DRAINAGE CERTIFICATION

DION'S CORPORATE ADDITION
ALEX HARRISON

GRADING AND DRAINAGE PLAN

GRADING AND DRAINAGE PLAN
DION'S CORPORATE HEADQUARTERS

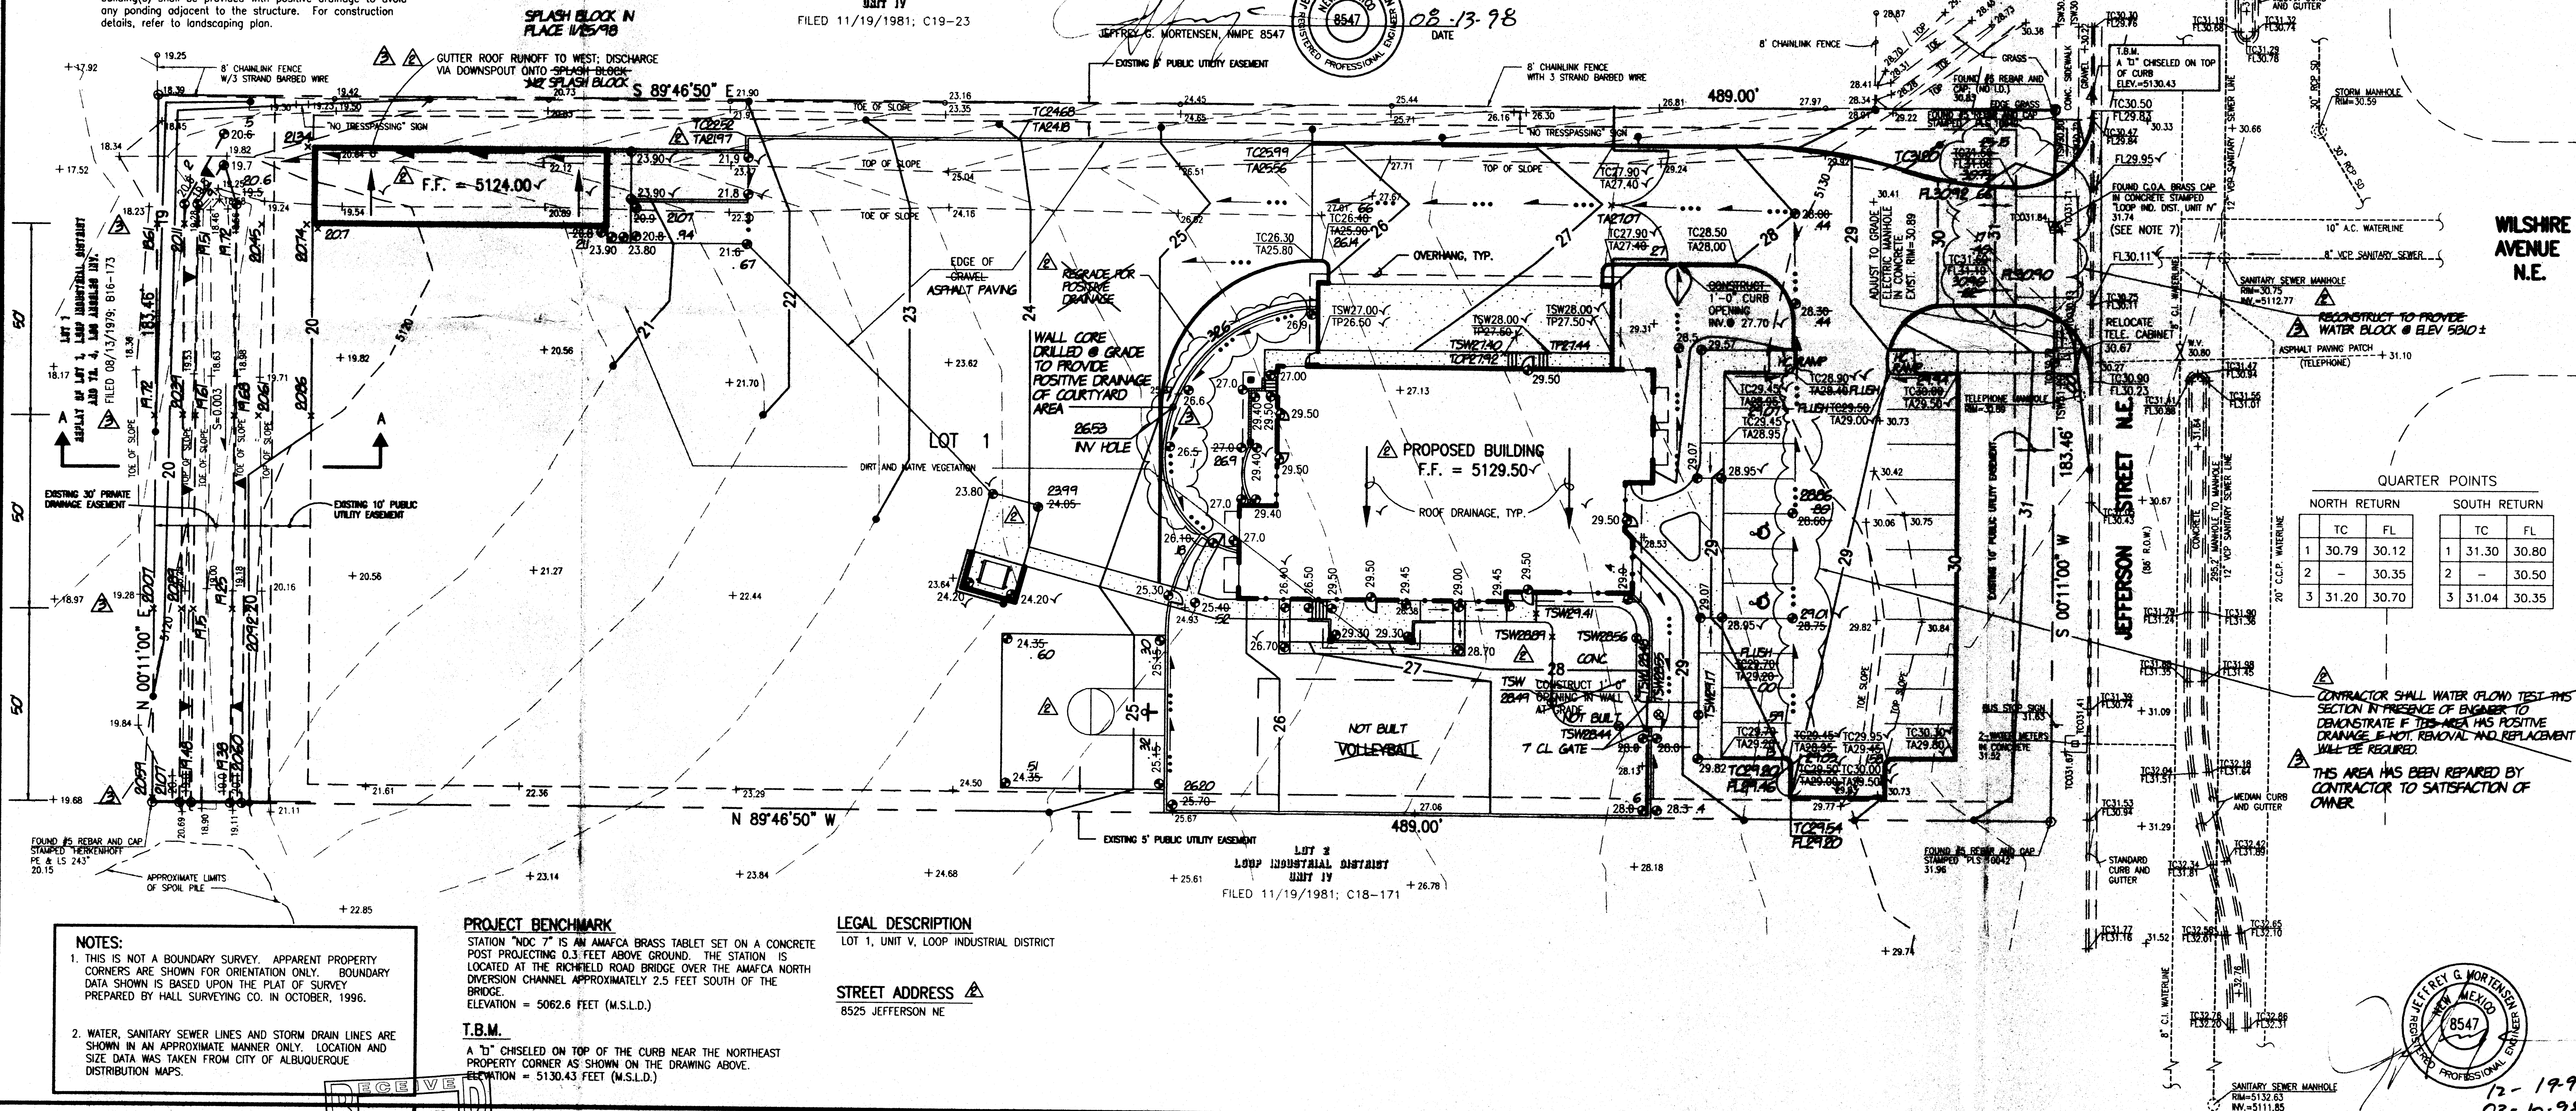
AS INDICATED BY THE AS-BUILT INFORMATION SHOWN HEREON, THE MAJORITY OF THIS SITE HAS BEEN GRADED AND DRAINED IN SUBSTANTIAL COMPLIANCE WITH THE APPROVED GRADING AND DRAINAGE PLAN. SEVERAL AREAS REQUIRING CORRECTION ARE NOTED. THESE AREAS MUST BE CORRECTED AND RECERTIFIED PRIOR TO ISSUANCE OF A PERMANENT CERTIFICATE OF OCCUPANCY.

1. THE PRIVATE ENTRANCE MUST BE RECONSTRUCTED TO PROVIDE A WATERLOK AT MINIMUM ELEVATION 5131.0.
2. THE ASPHALT PAVING AT THE FRONT OF THE BUILDING MUST BE WATER FLOWN) TESTED IN THE PRESENCE OF THE ENGINEER IN ORDER TO DEMONSTRATE THAT THIS AREA HAS POSITIVE DRAINAGE. IF THE AREA DOES NOT HAVE POSITIVE DRAINAGE, THEN THE CONTRACTOR SHALL REMOVE AND REPAVE THIS AREA TO THE REQUIRED ACCORDANCE WITH THE DESIGN GRADES AS APPROVED.
3. THE ENCLOSED COURTYARD AREA AT THE NORTHWEST CORNER OF THE BUILDING MUST BE REGRADED FOR POSITIVE DRAINAGE.
4. THE PRIVATE DRAINAGE EASEMENT AT THE WEST EDGE OF THE PROPERTY MUST BE REGRADED IN ACCORDANCE WITH SECTION A-A AS APPEARS OF SHEET 2 OF 2 OF THE APPROVED PLANS.
5. ADD SPLASHLOK AT NORTHWEST CORNER OF OUTBUILDING.
6. THE ABOVE CORRECTIONS MUST BE VERIFIED AND RECERTIFIED FOLLOWING SATISFACTORILY COMPLETION.

BASED UPON THE INFORMATION PRESENTED ABOVE, ISSUANCE OF A TEMPORARY CERTIFICATE OF OCCUPANCY IS HEREBY RECOMMENDED. PERMANENT CERTIFICATE OF OCCUPANCY SHOULD BE WITHHELD UNTIL SUCH TIME AS ALL CORRECTIONS HAVE BEEN MADE AND THE PROJECT RECERTIFIED. THE ABOVE INFORMATION WAS OBTAINED BY ME OR UNDER MY DIRECT SUPERVISION AND IS TRUE AND CORRECT TO THE BEST OF MY KNOWLEDGE AND BELIEF.

DRAINAGE PLAN, CALCULATIONS AND SECTIONS DION'S CORPORATE HEADQUARTERS

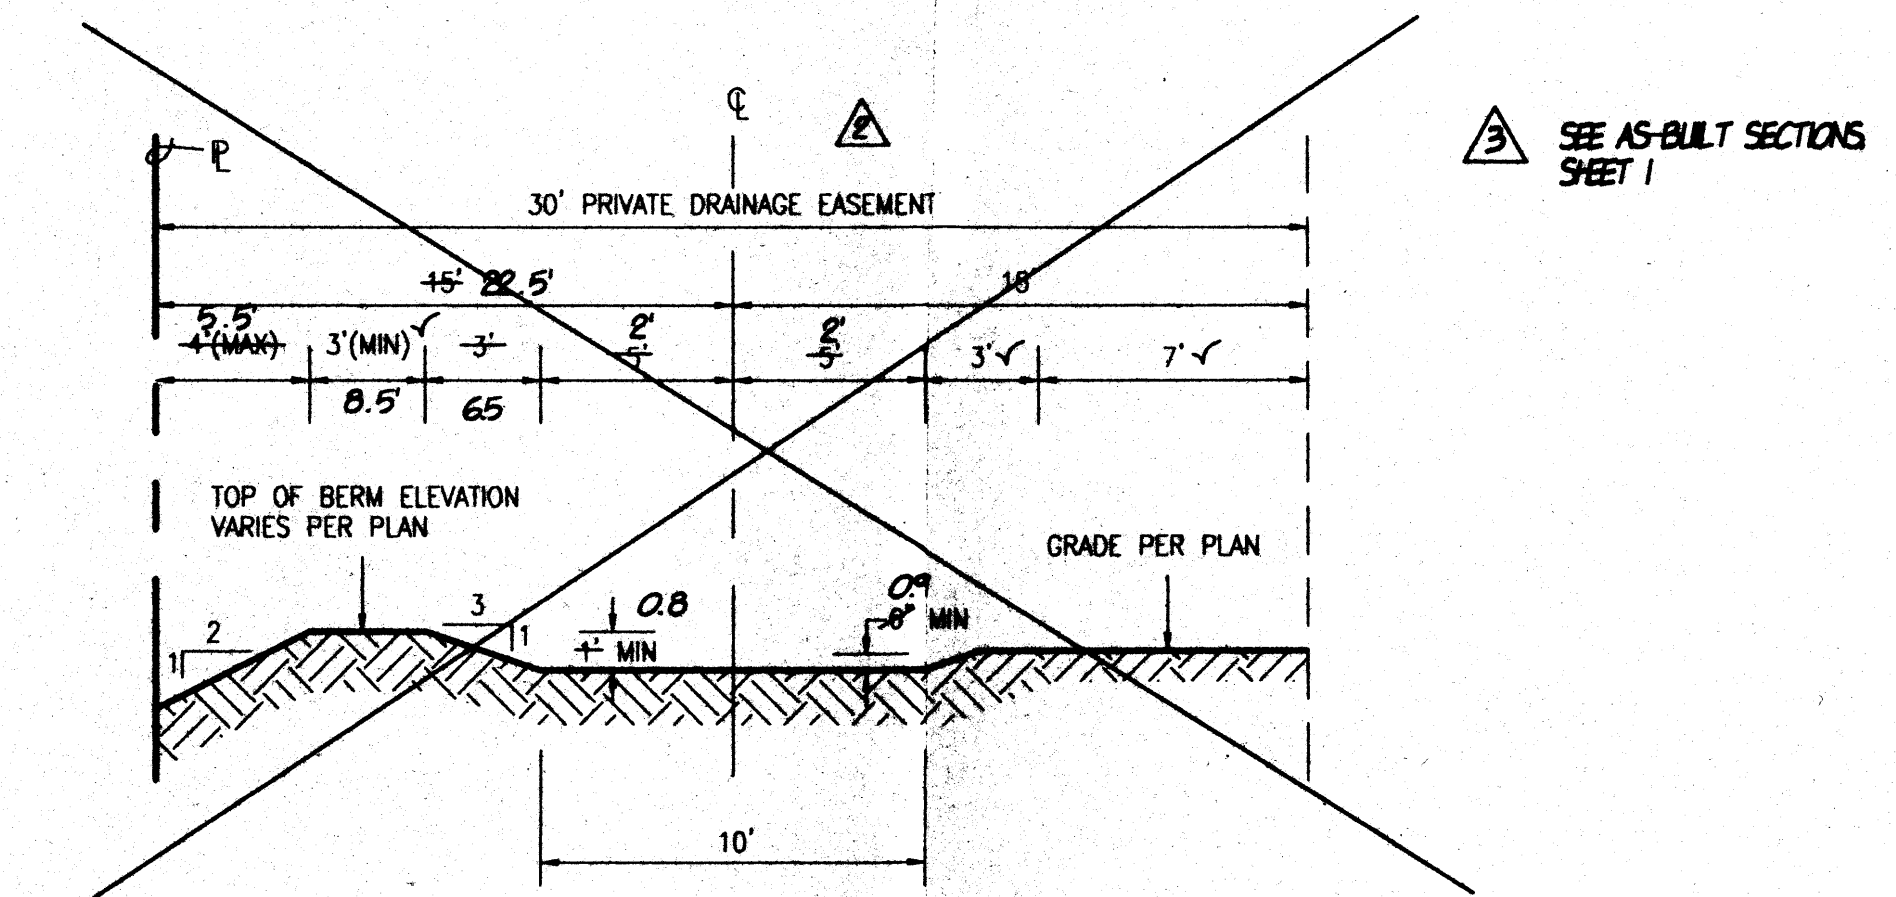
AS INDICATED BY THE AS-BUILT INFORMATION SHOWN HEREON, THE MAJORITY OF THIS SITE HAS BEEN GRADED AND DRAINED IN SUBSTANTIAL COMPLIANCE WITH THE APPROVED GRADING AND DRAINAGE PLAN. SEVERAL AREAS REQUIRING CORRECTION ARE NOTED. THESE AREAS MUST BE CORRECTED AND RECERTIFIED PRIOR TO ISSUANCE OF A PERMANENT CERTIFICATE OF OCCUPANCY.

1. THE PRIVATE ENTRANCE MUST BE RECONSTRUCTED TO PROVIDE A WATERBLOCK AT MINIMUM ELEVATION 5131.0.
2. THE ASPHALT PAVING AT THE FRONT OF THE BUILDING MUST BE WATER (FLOW) TESTED IN THE PRESENCE OF THE ENGINEER IN ORDER TO DEMONSTRATE THAT THIS AREA HAS POSITIVE DRAINAGE. IF THE AREA DOES NOT HAVE POSITIVE DRAINAGE, THEN THE CONTRACTOR SHALL REMOVE AND REPLACE THIS AREA OF PAVING IN ACCORDANCE WITH THE DESIGN GRADES AS APPROVED.
3. THE ENCLOSED COURTYARD AREA AT THE NORTHWEST CORNER OF THE BUILDING MUST BE REGRADED FOR POSITIVE DRAINAGE.
4. THE PRIVATE DRAINAGE EASEMENT AT THE WEST EDGE OF THE PROPERTY MUST BE REGRADED IN ACCORDANCE WITH SECTION A-A AS APPEARS OF SHEET 2 OF 2 OF THE APPROVED PLAN.
5. ADD SPLASHERLOCK AT NORTHWEST CORNER OF OUTBUILDING.
6. THE ABOVE CORRECTIONS MUST BE VERIFIED AND RECERTIFIED FOLLOWING SATISFACTORILY COMPLETION.

BASED UPON THE INFORMATION PRESENTED ABOVE, ISSUANCE OF A TEMPORARY CERTIFICATE OF OCCUPANCY IS HEREBY RECOMMENDED. PERMANENT CERTIFICATE OF OCCUPANCY SHOULD BE WITHHELD UNTIL SUCH TIME AS ALL CORRECTIONS HAVE BEEN MADE AND THE PROJECT RECERTIFIED. THE ABOVE INFORMATION WAS OBTAINED BY ME OR UNDER MY DIRECT SUPERVISION AND IS TRUE AND CORRECT TO THE BEST OF MY KNOWLEDGE AND BELIEF.
